# FNDC Proposed District Plan

## Submission review – Transport Chapter

<b>Prepared for</b>	Far North District Council
<b>Project Number</b>	FNDC-J011
<b>Revision</b>	C
<b>Issue Date</b>	24 March 2025
<b>Prepared by</b>	Mat Collins, Associate Transportation Engineer
<b>Reviewed by</b>	Logan Copland, Principal Transport Planner

**Figure 2.1 Examples of unsafe and poorly designed pedestrian accesses, from Auckland Council monitoring**

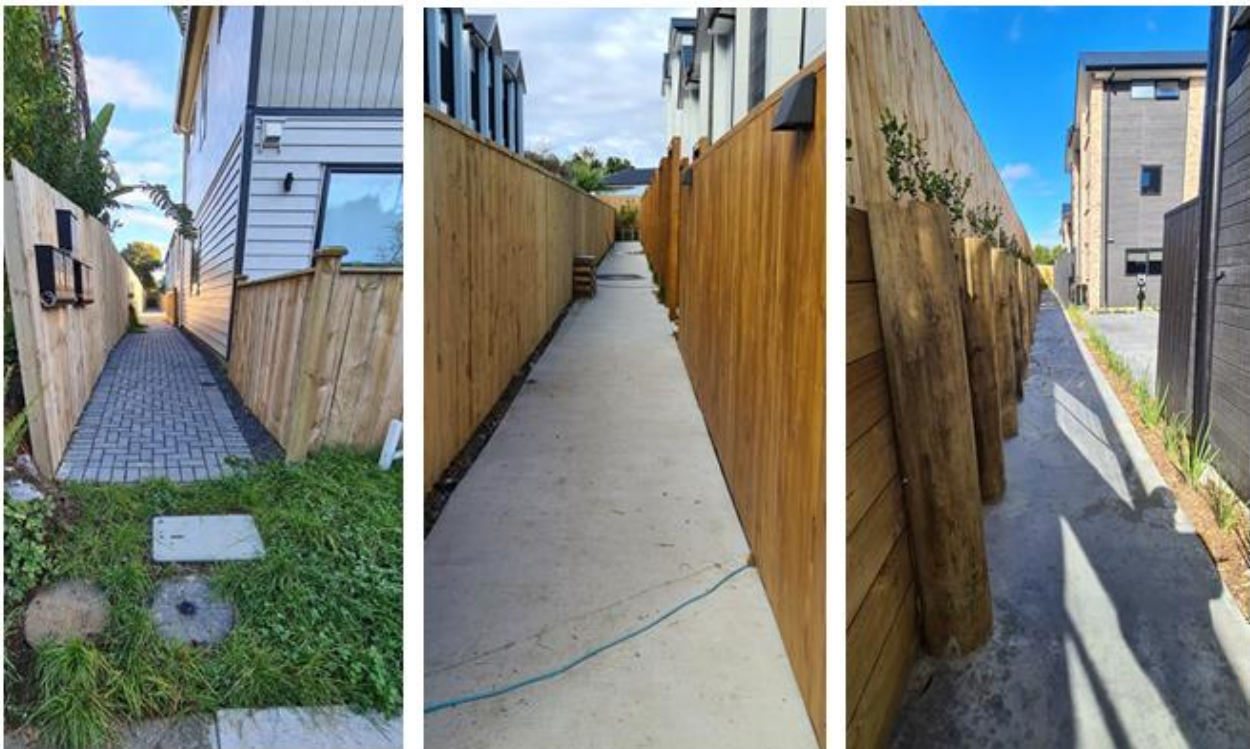
Some examples of unsafe and poorly designed pedestrian accesses, from Auckland Council monitoring, are shown in Figure 2.1.

While I expect pedestrian access is less likely to be an issue for Council, given that medium density development without vehicular access is less likely in the Far North District, I recommend that provisions are included in the PDP to avoid issues over the lifetime of the PDP.

I have included *TRAN-RW Design and location of pedestrian access for allotments where vehicle access is not provided* in Appendix A. I have based this on Unitary Plan Standard E27.6.6, although I have significantly simplified the proposed rule, acknowledging that this issue is far less likely in the Far North District compared to Auckland.

All zones	TRAN-Figure 1 - Manoeuvring and parking space dimensions					
	Parking Angle	Width of Parking Space	Kerb Overhang	Depth of Parking Space	Manoeuvring Spaces	Total Depth One Row
90° Regular Users <sup>(1)</sup>	2.4 <sup>(3)</sup>	1.0	4.9	7.1	12.9	16.9

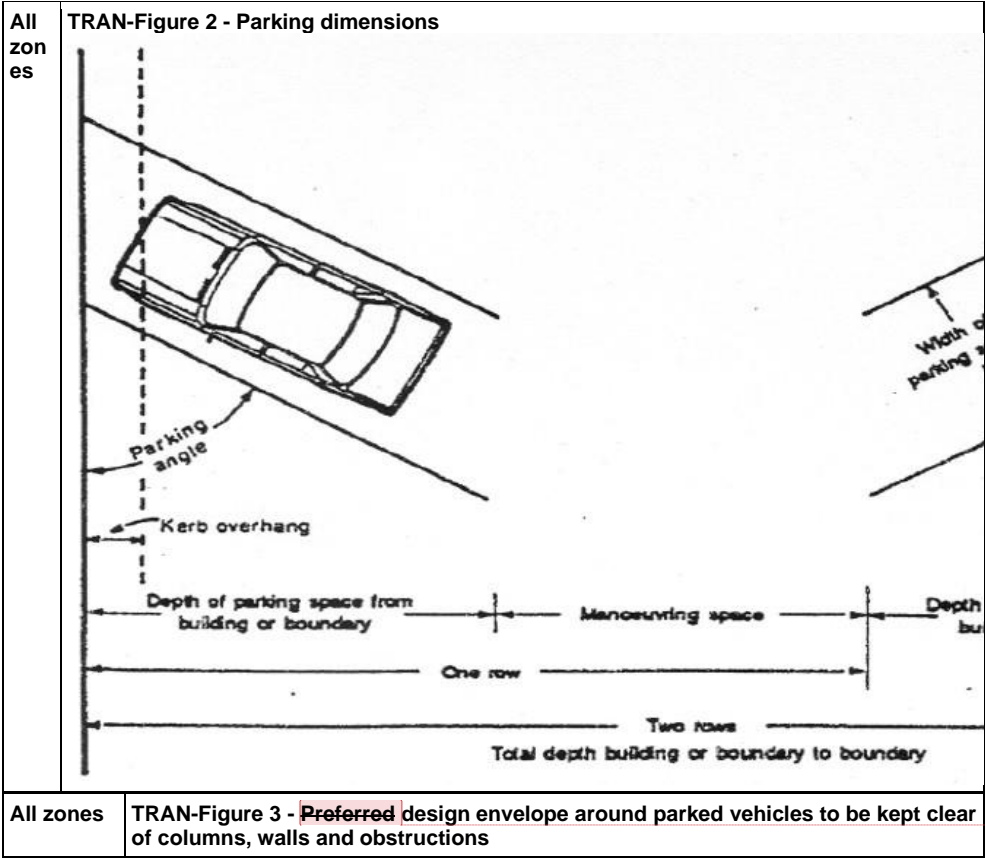
TRAN-Table 5 Figure 1	Amendment to include dimensions for accessible parking spaces and more clearly define which parts of the table are directive and which are explanatory
TRAN-Table 9	<p>TRAN-Table 9 specifies accessway design requirements for residential accessways, however there are currently no requirements for non-residential activities. Section 3.2.28.1 of the ES specifies private accessway design requirements for industrial, commercial and rural land uses, and I recommend that these are included in TRAN-Table 9.</p> <p>I also recommend that accessway design is based on number of allotments rather than number of residential units. I have also amended the threshold for accessway design to include accessways that serve single allotments (such as pan-handle sites).</p>

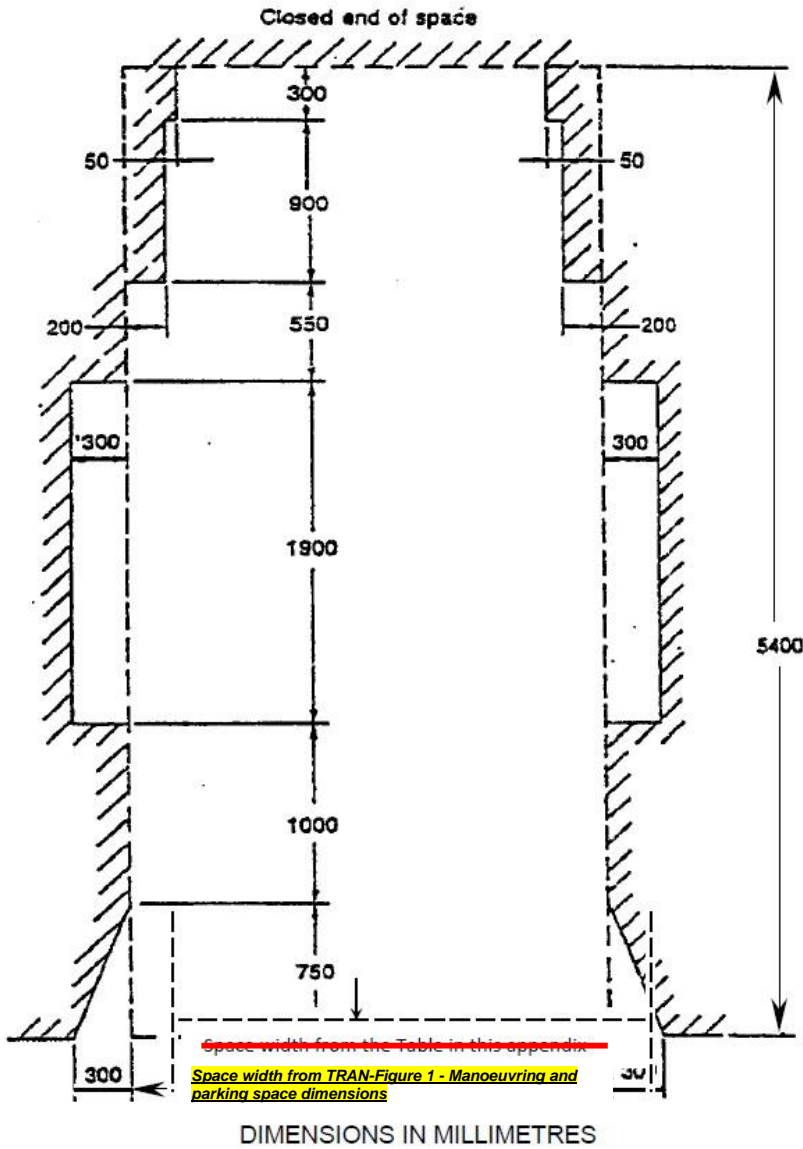
tracking curves. Therefore, I recommend retaining these. That said, I propose an amendment to TRAN-Figure 3, which the PDP currently describes as the “preferred design envelope.” Given that TRAN-S1.5 requires all car parking to comply with TRAN-Table 5, TRAN-Figure 3 should be made directive since it forms part of TRAN-Table 5.

**Commented [MC60]:** Amend "Space width from the Table in this appendix" as this should reference TRAN-Figure 1 parking space dimensions

**Commented [MC61]:** Decouple ES from PDP. TRAN-Figure 3 needs to be directive.

**TRAN-Figure Y - Restart Sight Triangles for all Level Crossings**

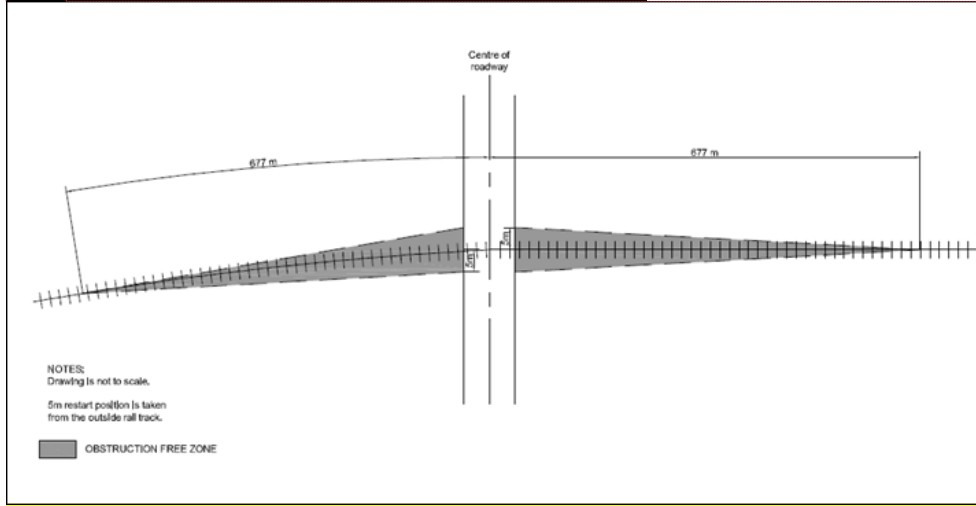
Many district plans include rules/standards relating to vehicle crossings near level rail crossings. The Rules proposed by KiwiRail are generally consistent with other district plans<sup>33</sup> and <sup>34</sup>. I have adopted KiwiRail’s requests with minor amendments:

Commented [MC78]: S416.029

- New Rule TRAN-R2A PER-1 references the “edge of the vehicle crossing” rather than the “edge of seal on the proposed vehicle access point” as some vehicle crossings are not sealed.
- New Rule TRAN-R2B matters of discretion, amending “Any implications arising from advice from KiwiRail” to “The outcome of any consultation with KiwiRail” for the sake of consistency with other Rules
- New Standard TRAN-S6, adding a note to clarify that the restart and approach sightlines only apply to level crossings that are not controlled by barrier arms.
